Re: A Report by Newfoundland and Labrador Hydro (Hydro) pursuant to Order No. P.U. 22(2016) regarding the refurbishment of the gas generator engines at the Hardwoods Gas Turbine Plant and the Stephenville Gas Turbine Plant –Updated Report

Gas Turbine Failure Analysis Recommended Actions Implementation Update

A Report to the Board of Commissioners of Public Utilities

Fig 2. Altair 3-Way Valve at Hardwoods.

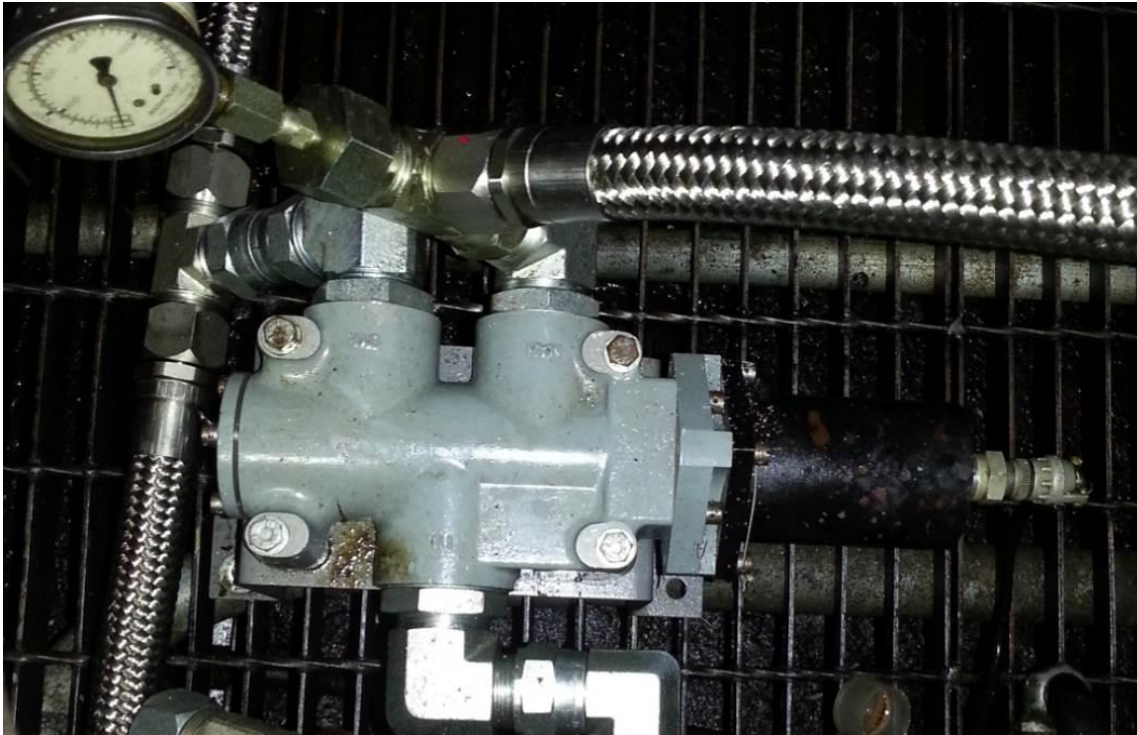
Hydro employees report the Altair 3-way shut-off valves to have been found to leak past the seals on several occasions and failing to provide adequate isolation. On those occasions Hydro or Alba power have changed the O-rings themselves.

Altair were bought out by Midland Ross approximately 20 years ago, who in turn were bought by Honeywell. Honeywell were unable to provide any information on this valve when asked. Although not substantiated, it was reported that Honeywell no longer support the Altair products which means effectively the OEM no longer exists so overhaul by the OEM is impossible.

It is recommended that the valve is replaced with a current type

Fig 3. LF-7 Atkomatic Recirculation Valves SVL 32840 (Left) HWD 31840 (Right)

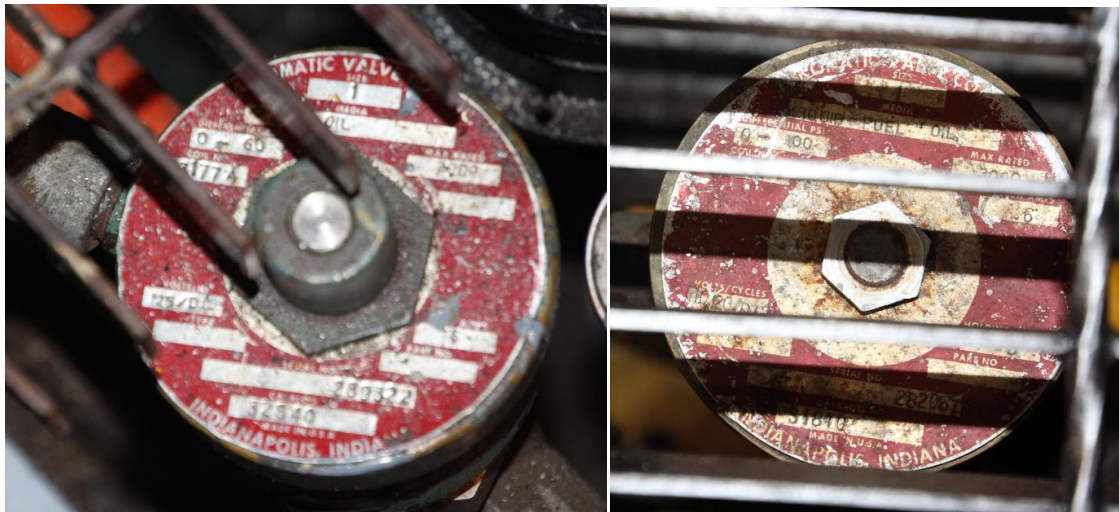
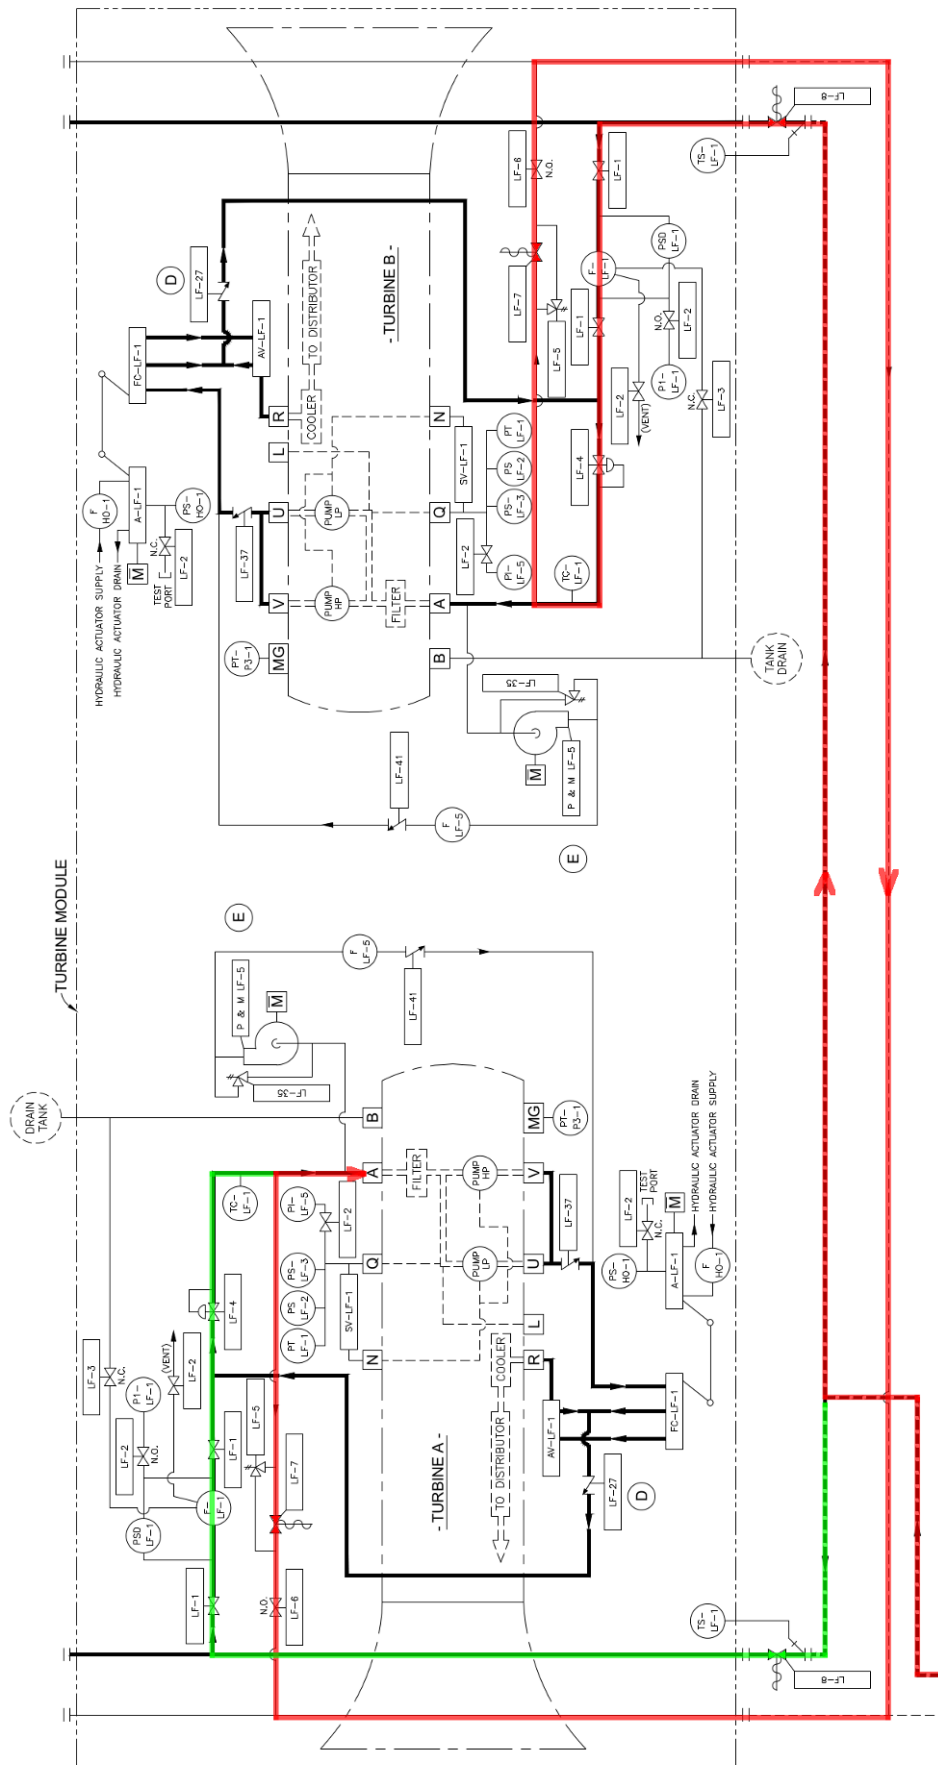
Fail open is inappropriate for LF-7 since the consequence of it failing open or leaking badly is to defeat the action of LF-8 the external block valve intended for fire shutoff. If LF-8 is closed, the turbine will carry on running on fuel drawn in via the open LF-7 and return line with potentially dangerous consequences.

- LF-7 has failed open on Turbine A.
- Fuel is being supplied from the fuel forwarding module.
- Turbine A is running.
- Turbine B is not running.
- LF-7 is open on Turbine B, for recirculation due to TS-LF-1 sensing fuel temperature at that point dropping below 5°C.
- Personnel notice an issue with Turbine A (such as an undetected fire through the window).
- Personnel manually close external block valve LF-8.
- LF-8 closure stops main fuel flow to turbine (Green line illustrates no flow).
- Turbine A engine driven pumps draw fuel backward through return line via failed LF-7 of Turbine A. This fuel is available from Turbine B's open LF-7 and LF-8. (Red line illustrates flow).

This failure mode has been witnessed at Stephenville, although not in an emergency. One turbine had been successfully started with hand valve LF-1 unintentionally left closed (in the main fuel supply). The unit started, the generator synchronised, however exported electrical power was limited to 2MW by the restricted fuel flow. Investigation found that hand valve LF1 had been left closed, and the fuel had been flowing through the faulty open LF-7 from the other turbines recirculation connection.

- Install a current type of normally closed valve and change the control logic to suit.
- Install check valves in the recirculation lines.
- Implement a test regime.

Fig 7. FC-LF-1 Woodward LQ25 at Stephenville

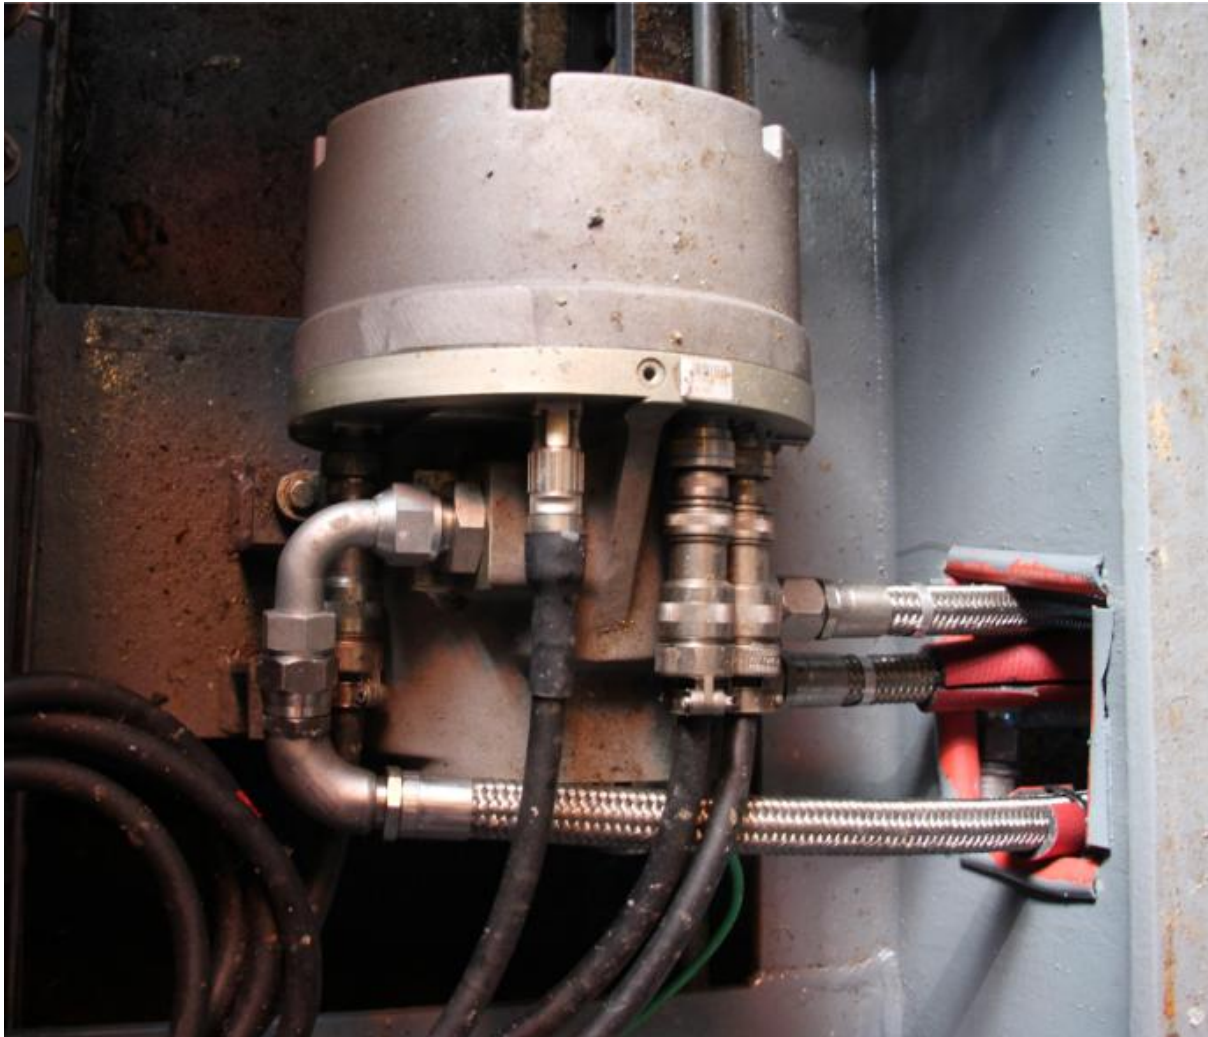
Woodward confirmed the LQ25 (9908-233M) internal SOV is not capable of achieving any SIL rating under IEC 61511. A separate shut off valve should be used to implement a segregated protection function.

Fig 12. SVL GGB LF-8 External block valve with manual operation handle.

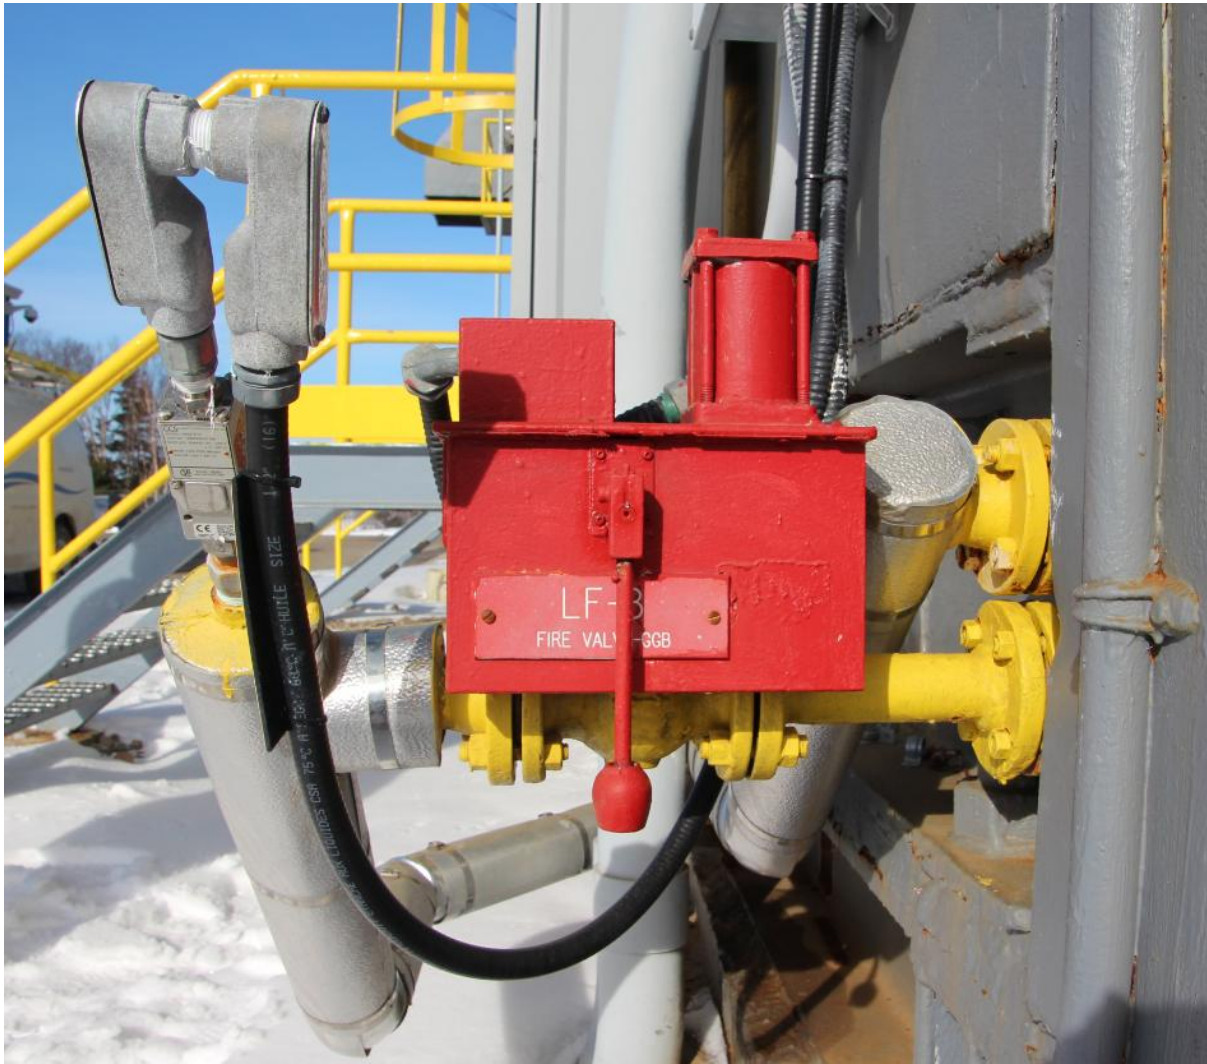
At the unit, the manual levers of the LF-8 external block valves (fire) provide a facility to manually shut down each turbine, however there is no signage to make that clear to anyone without prior knowledge. It is recommended to install signage so that a competent but un-briefed person could use the valve in an emergency.

Closing one LF-8 will only close the fuel off to the one gas turbine, allowing the other to continue running.

Fig 21. Rolls-Royce packaged Olympus gas generator lube oil system (GGLO)

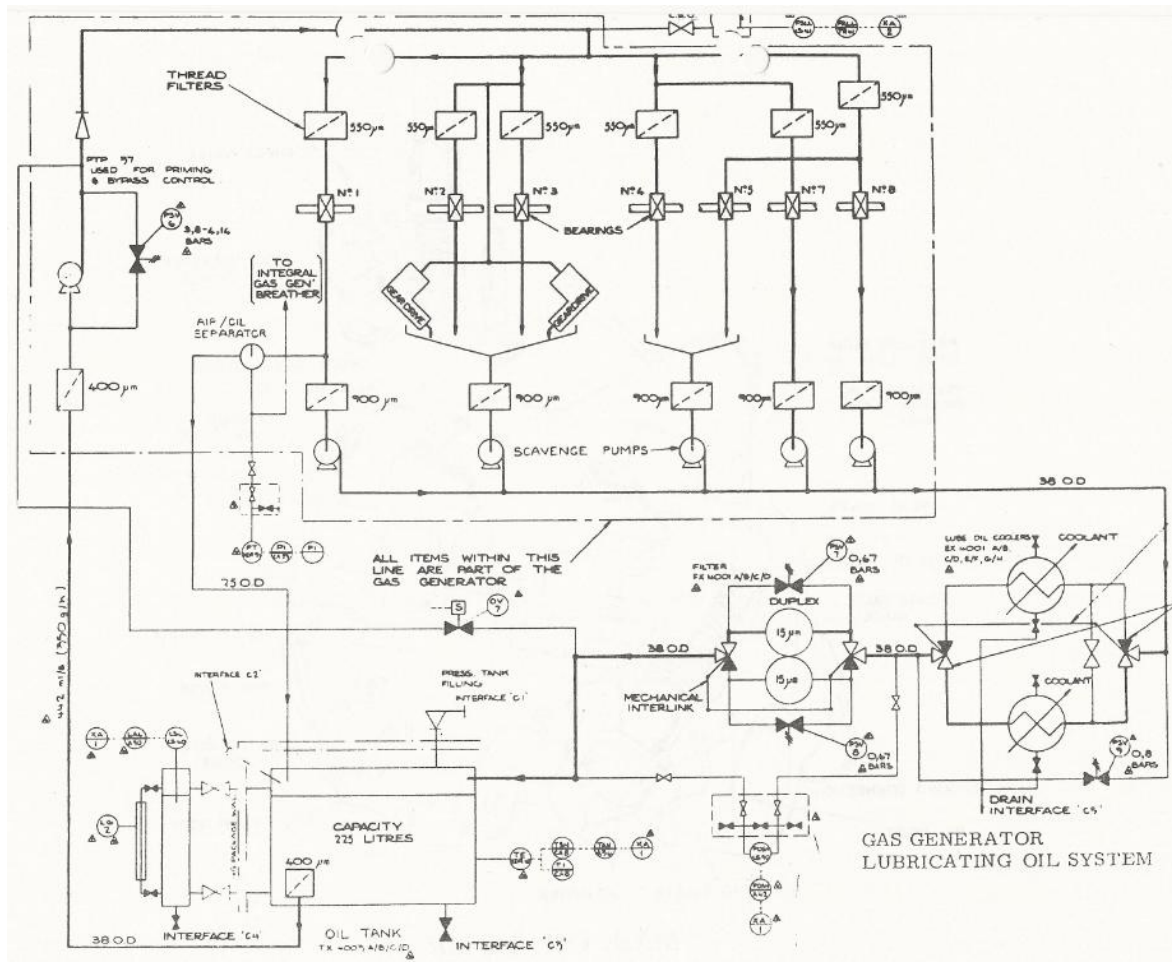
The RR Drawing (Fig 21) shows a 400µ strainer on the draw-off from the tank additional to the 400µ strainer at the pressure pump suction.

The RR design shows a 400 μ filter at the tank outlet which would catch much of the contamination eg commissioning debris which might be introduced through the tank. It is not fine enough to catch wear debris. The absence of the tank outlet strainer in the CW arrangement is not seen as problematic because the engine mounted 400 μ filter in the suction to the LO pressure pump makes it redundant.

Fig 22. Extract from LO tank drawing 495033

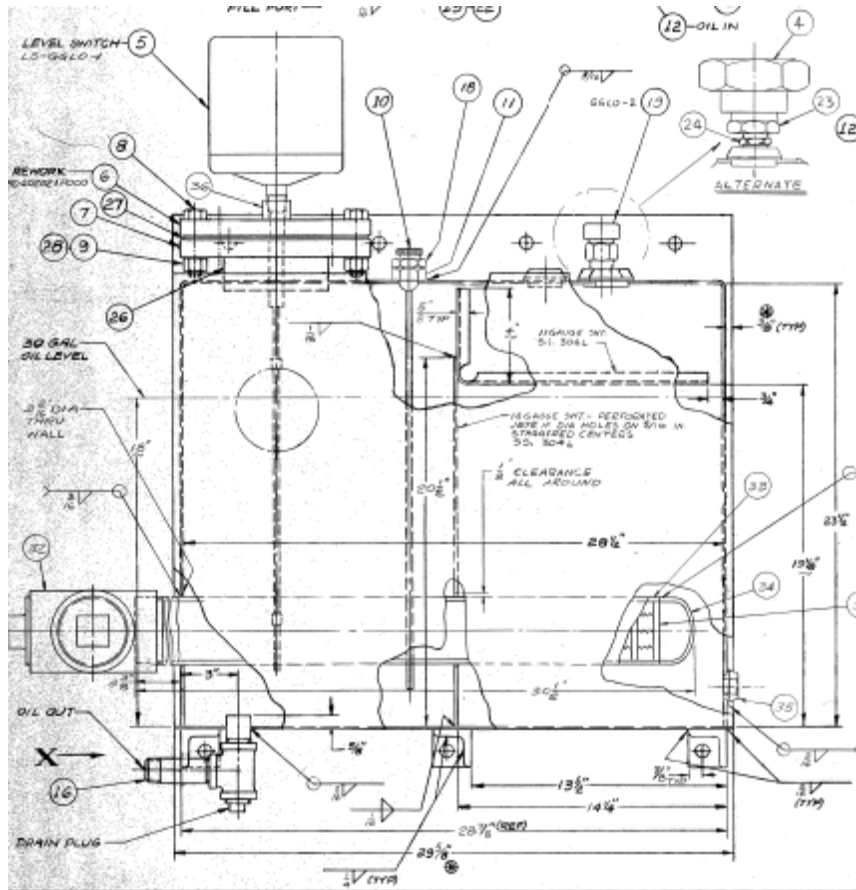
The design of the LO tank has weakness in the draw off arrangement, the offtake is common with the drain and has only a 5/8" upstand from the bottom of the tank. In a typical arrangement the draw off would be elevated to prevent bottom sediment and water (BS&W) from being delivered to the engine, and the drain would be at the lowest point in the bottom of the tank to allow BS&W to be removed. The intermittent operation of the engine increases the risk associated with the draw off; if a bottom layer accumulates to the point where it is leaving with the oil being drawn off, then when the engine shuts down the material in suspension will settle and as the layer thickens material will be displaced into draw off pipework below the tank.

- a. Install a valve on the gas generator lubricating oil tank drain point, e.g., reduce and use ½" instrument valve.
 - b. If practical, change the draw off point to elevate it above the tank bottom.
